Global Change Notification (GCN)

Product Family Impact 85 Ohm4P Daughtercard receptacle 10675941

Reason For Change Product Component Change

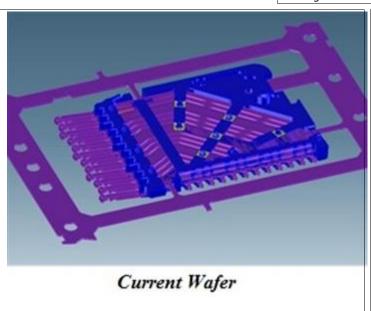
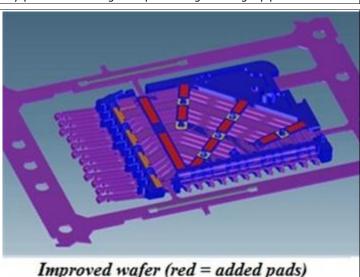
This letter is to inform you that in an effort for continuous improvements, Molex is implementing a running change on the following series: 170340 - Impact 850hm Plus 4P Daughtercard receptacle; 172056 - Impact 850hm Plus 4P Daughtercard receptacle without plus clip. The below pictures show the addition of plastic (in red) which improves the consistency of wafer-to-wafer spacing during the assembly process resulting in improved signal integrity performance.
